SERVICE BULLETIN

SB036-0697

Subject: Gear Locking Solenoid (Lancair IV & IV -P)

Status: Mandatory Change

Figure 1
Solenoid detail

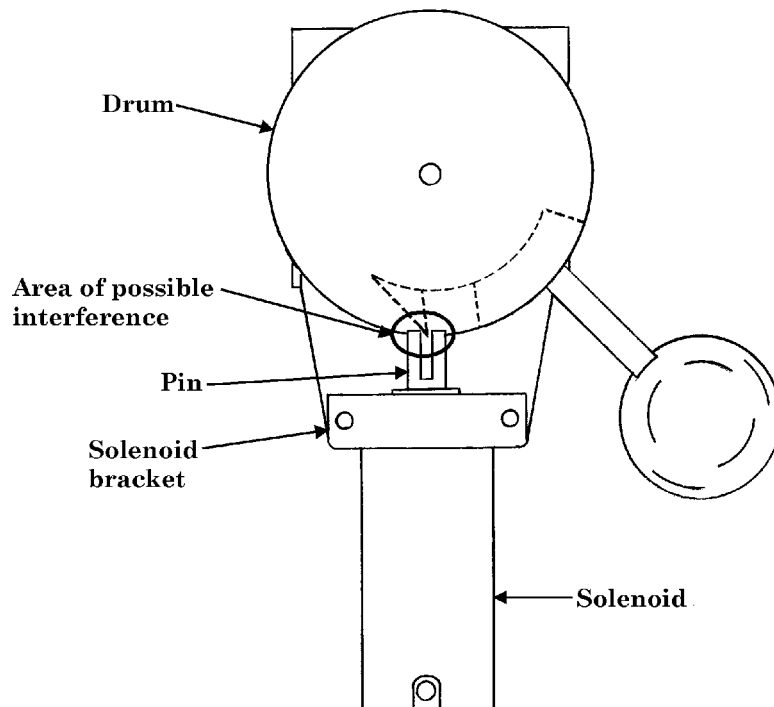
Background: The slot in the gear solenoid pin(part number 475 -6-10) in the gear locking solenoid may interfere with drum rotation.

Action: Remove the gear drum. Remove the gear down lock bracket, spring, and washer. Remove the gear solenoid pin and replace it with the new one. Install the circular clip, rubber washer, area washer, and spring on the new pin.

Figure 2
Pin Detail

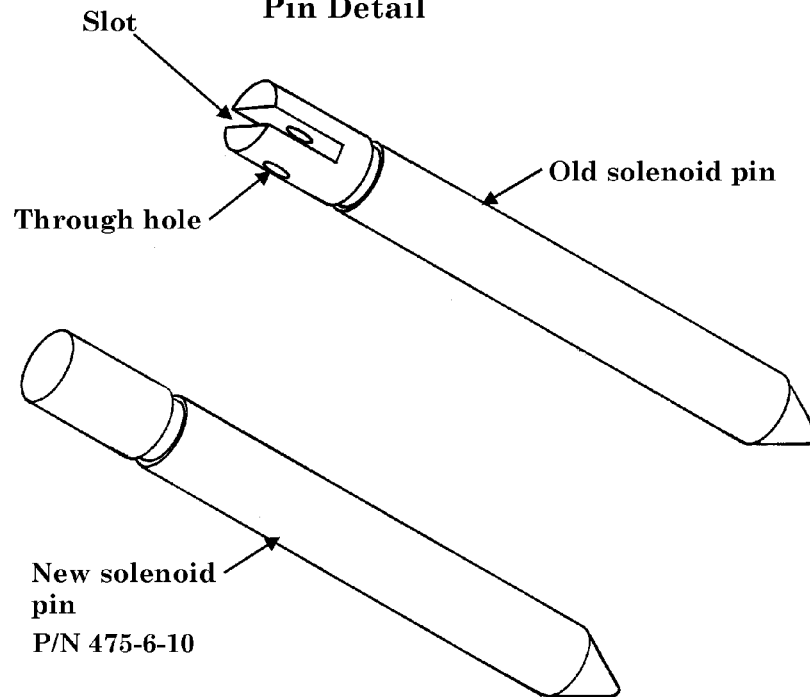
A new solenoid pin(P/N 475 -6-10) has been manufactured to replace the old pin.
